To: T10 Technical Committee
 From: Rob Elliott, HP (elliott@hp.com)
 Date: 26 April 2007
 Subject: 07-090r0 SAS-2 Transmit IDENTIFY three times

Suggested changes to SAS-2

Figure 1 — Identification sequence

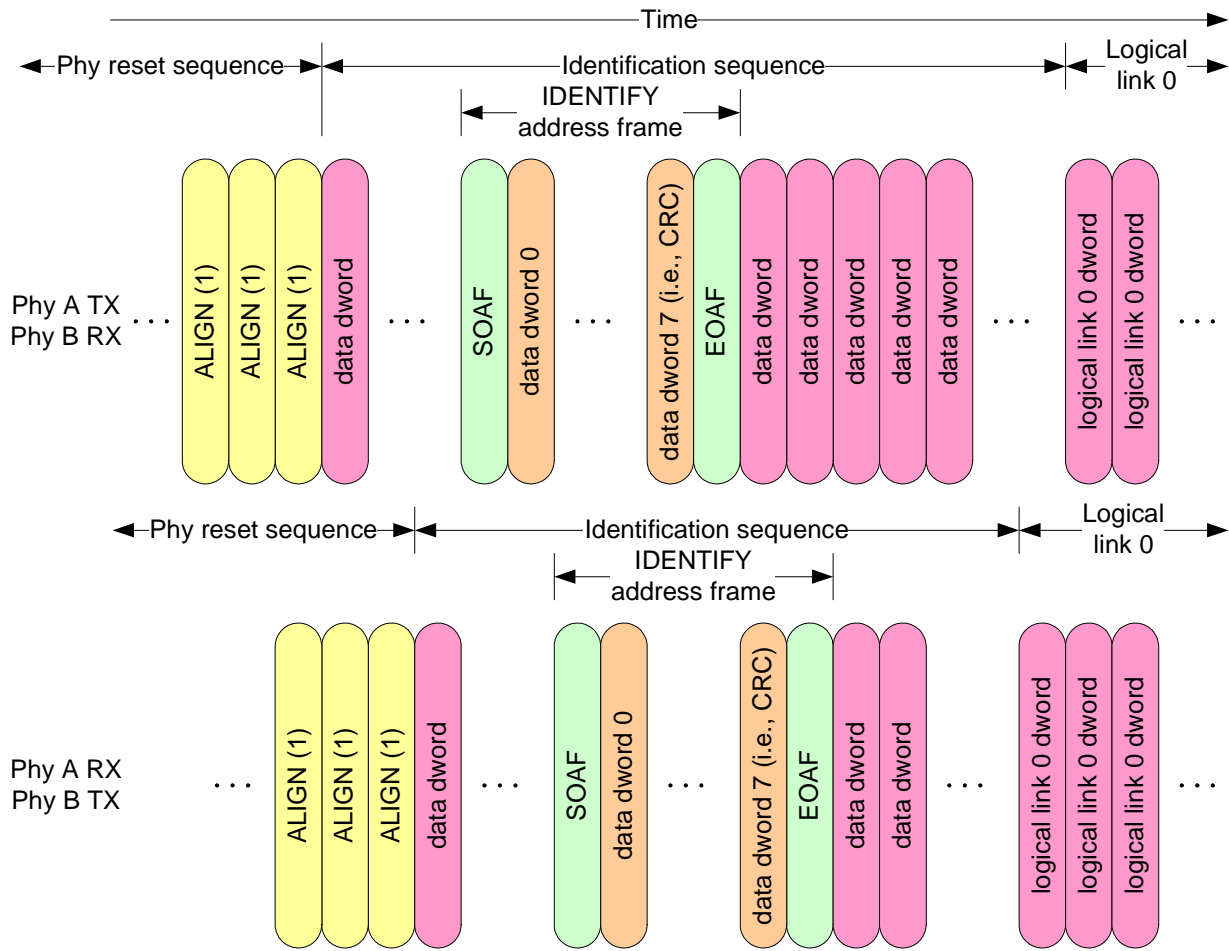
Figure 1 shows two phys with multiplexing disabled performing the identification sequence. Only one IDENTIFY address frame is shown in this example.

Figure 2 — Hard reset sequence

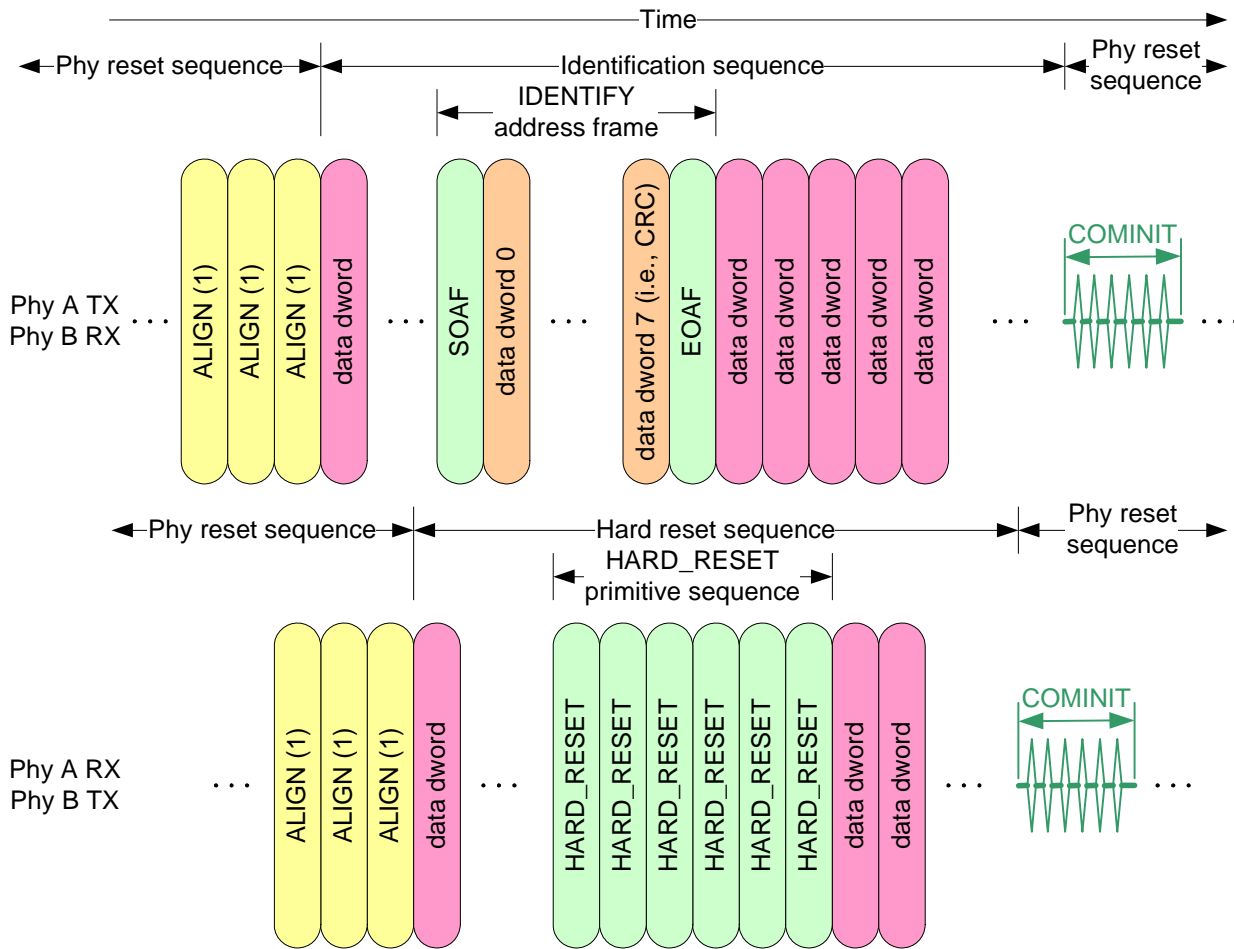
Figure 2 shows phy A performing the identification sequence and phy B performing the hard reset sequence. Multiplexing is disabled and only one IDENTIFY address frame is shown in this example.
